APPLICATION TO THE OHIO POWER SITING BOARD

FOR AN AMENDMENT TO THE CERTIFICATE OF ENVIRONMENTAL COMPATIBILITY AND PUBLIC NEED FOR

Powell Creek Solar

Case No. 22-0915-EL-BGA

Figure 03-2b

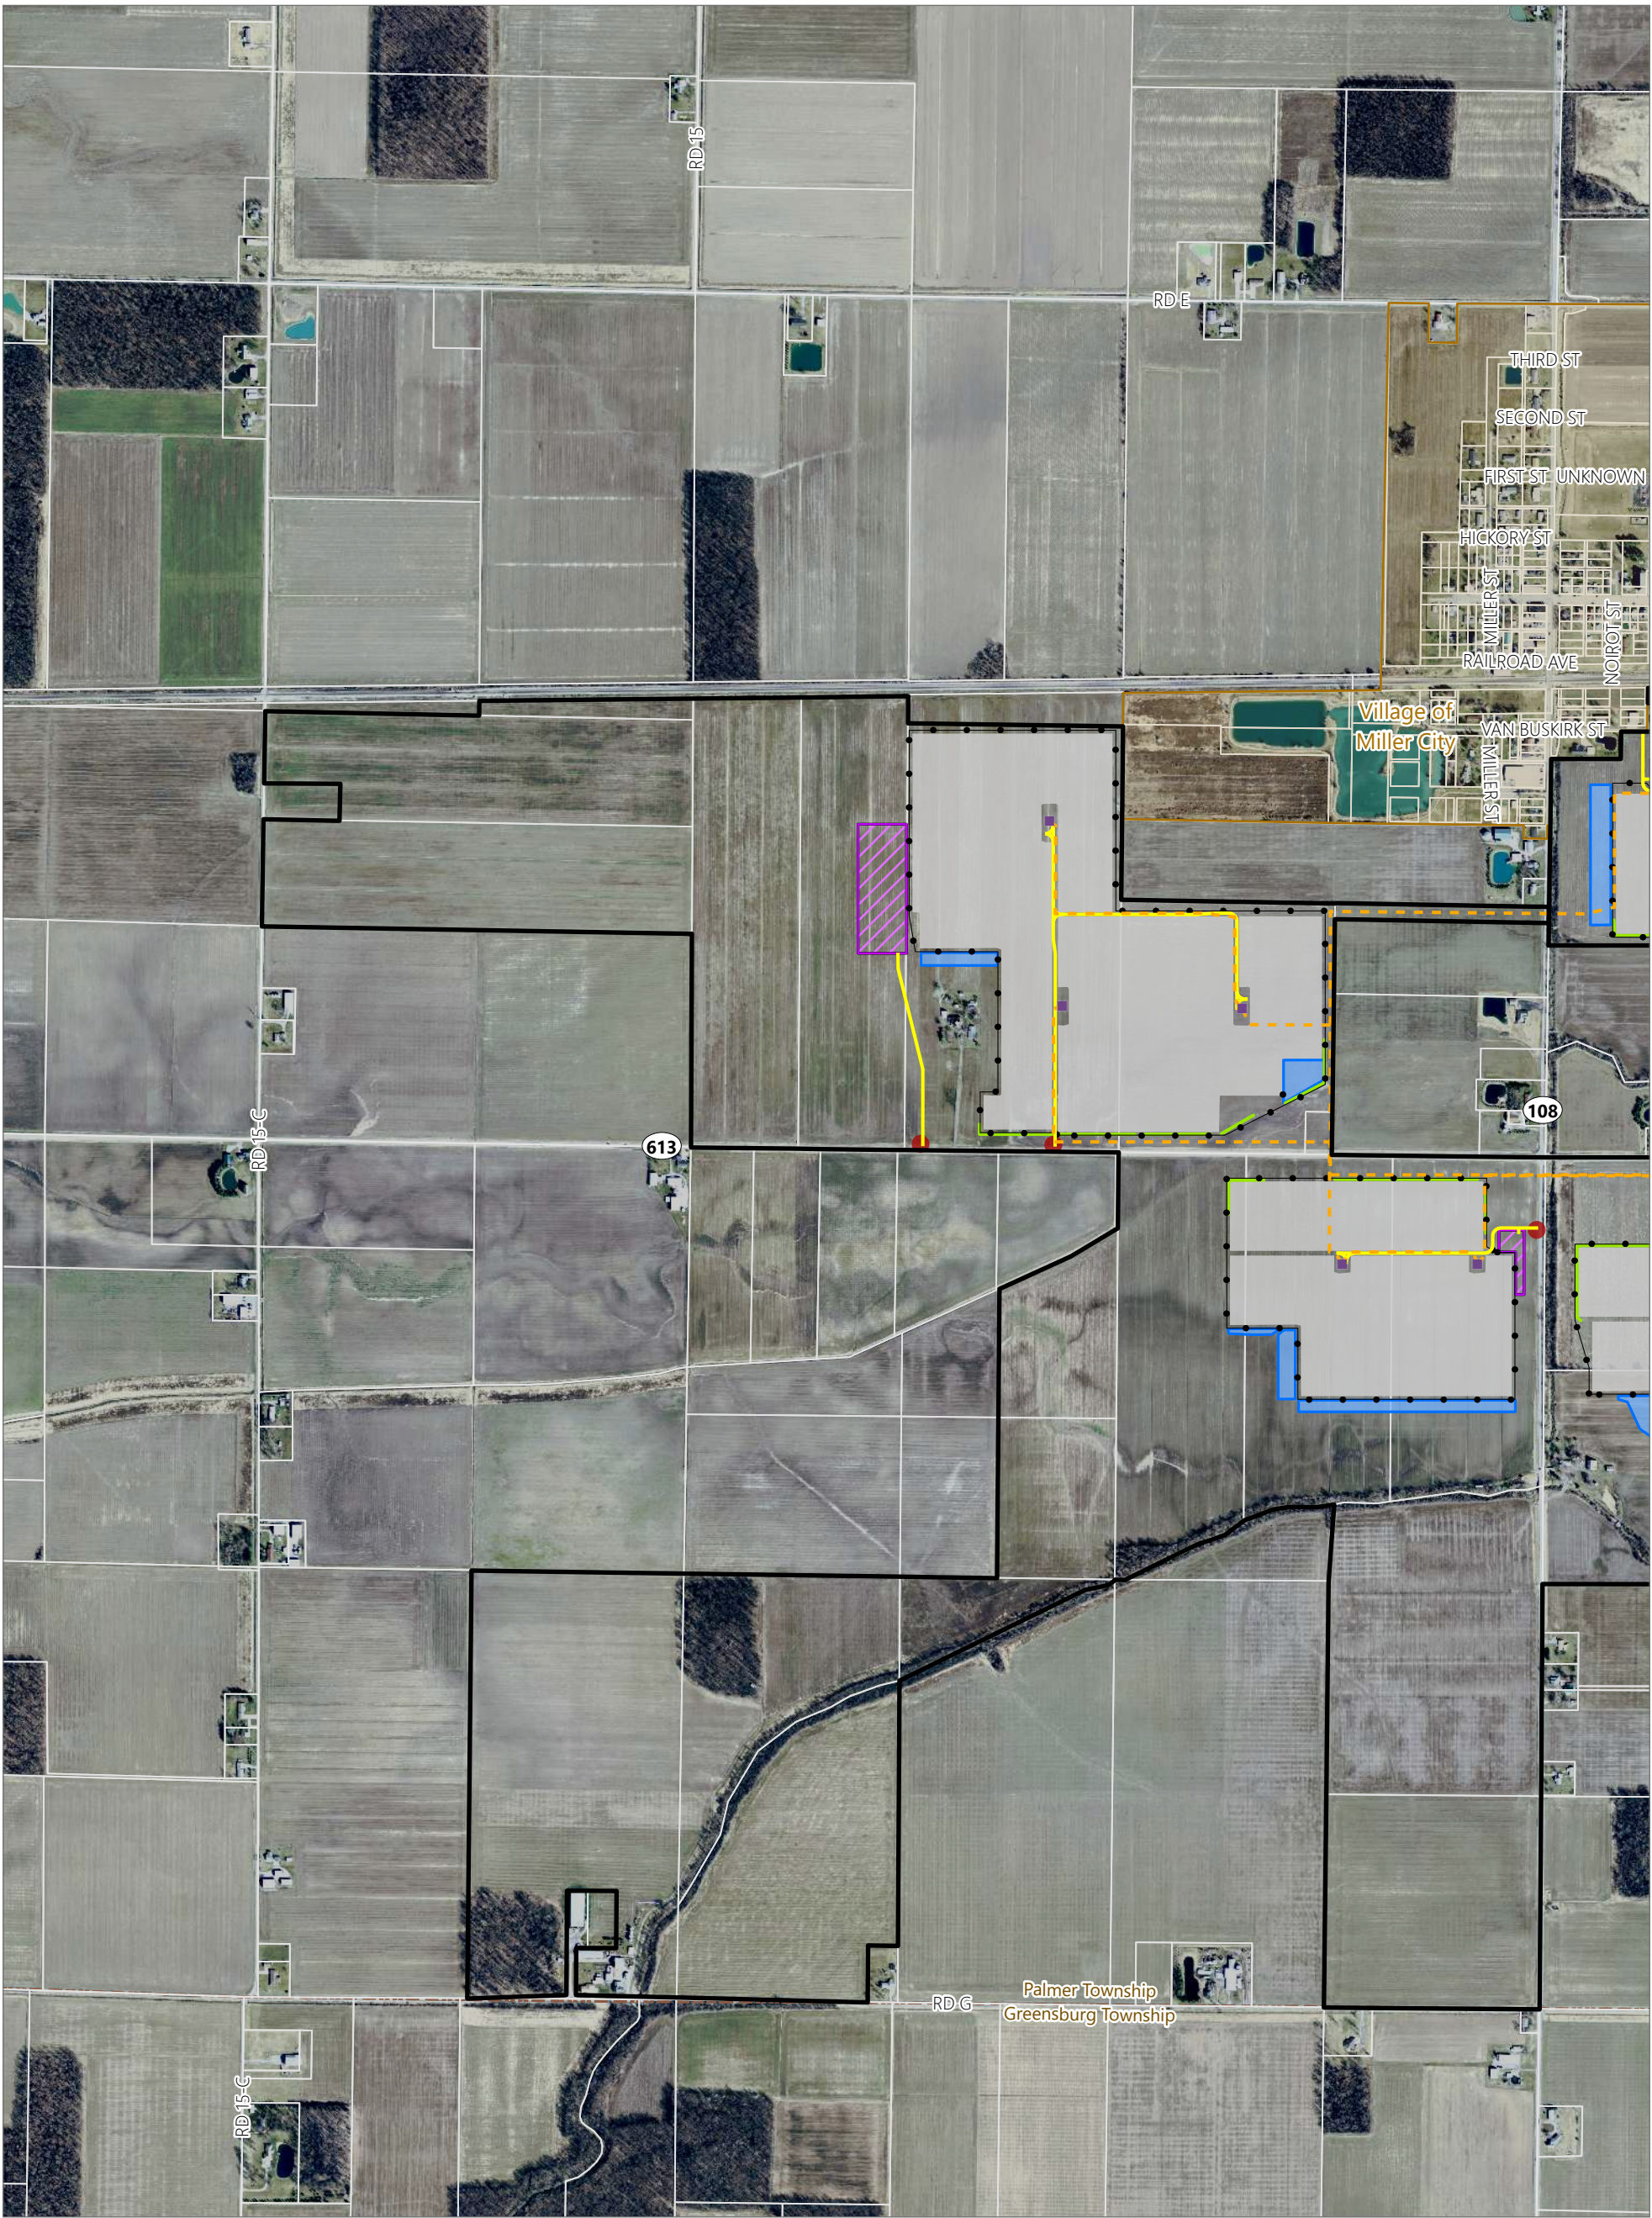
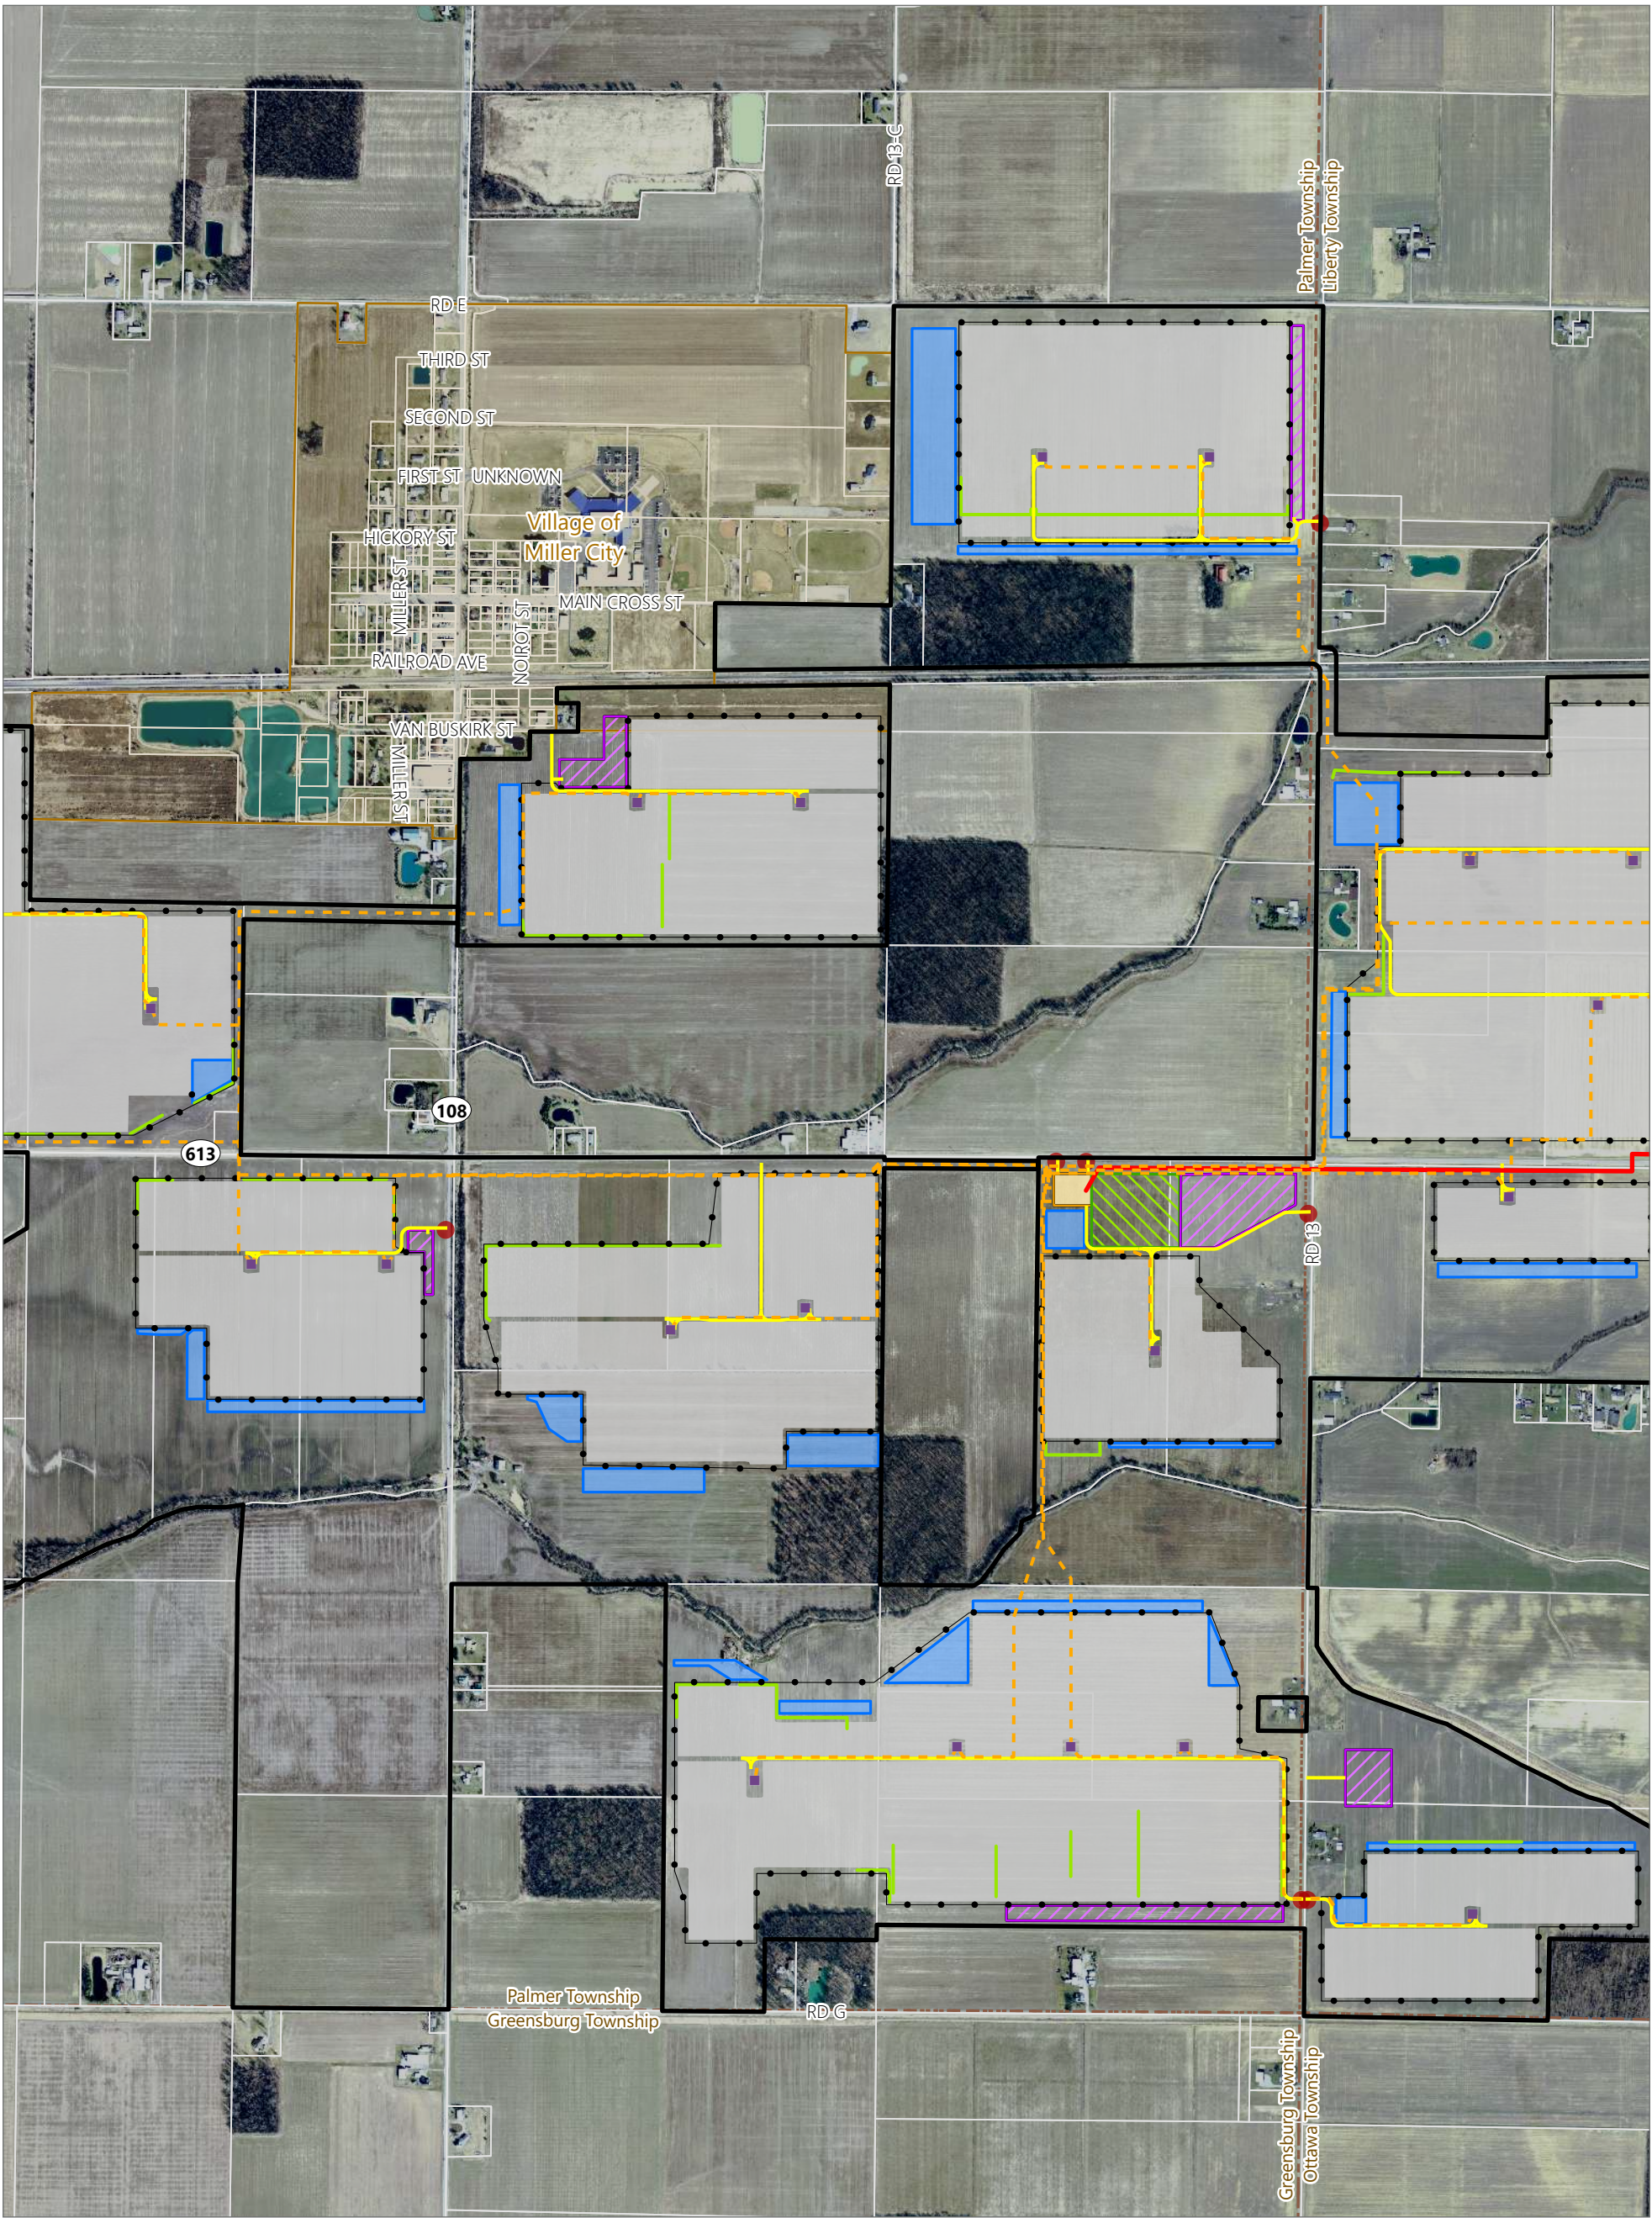
The two additional alternative preliminary Facility layouts, presented in Figure 03-2a and Figure 03-2b, include the fenceline, PV panel area, below ground collection lines, inverters, access roads, collection substation, O&M building, laydown yards, transmission line, and POI switching station contained in the Project Area. While the Applicant expects that the final Facility layout will remain substantially similar to the preliminary Facility layout provided in the Initial Application or the two additional alternative preliminary Facility layouts provided herein, due to ongoing technological innovations in the solar industry, continuing detailed engineering and survey work, public feedback, and communications during the OPSB certification process, the precise locations of these features within the Project Area are subject to change. While the layout is subject to change, all Facility components will be located within the Project Area that has been studied for environmental, cultural, engineering, and visual impacts, and will be subject to the various conditions and constraints provided in this Amendment Application, as well as the requirements of the Certificate issued in the Initial Application case.

The general description of collection lines, circuits, transformers, and installation methods remains the same as filed in the Initial Application. However, the lengths of buried collection cable for each of the additional tracker layouts presented in this Amendment Application are shorter than for the layout in the Initial Application. The ATI layout will require approximately 12.6 miles of buried collection cable, while the STI-PVH layout will require approximately 12.3 miles of buried collection cable. The preliminary design locations for buried collection cable with each tracker design option are shown in Figure 03-2a and Figure 03-2b.

The general description of the substation, the switching station, transformers, inverters, and installation methods remains the same as filed in the Initial Application. For this Amendment Application, the ATI tracker configuration includes 27 inverter locations and the STI-PVH tracker configuration includes 28 inverter locations, as shown in Figure 03-2a and Figure 03-2b.

The general description of Project Area access road size and construction methods, as well as the lack of crane paths, remains the same as filed in the Initial Application. For this Amendment Application, the ATI tracker configuration includes approximately 7.5 miles of access roads and the STI-PVH tracker configuration includes approximately 7.4 miles of access roads. Both measurements include approximately 0.3 mile of access roads that will be temporary, as they only serve to provide access to temporary laydown yards. Access roads are shown Figure 03-2a and Figure 03-2b.
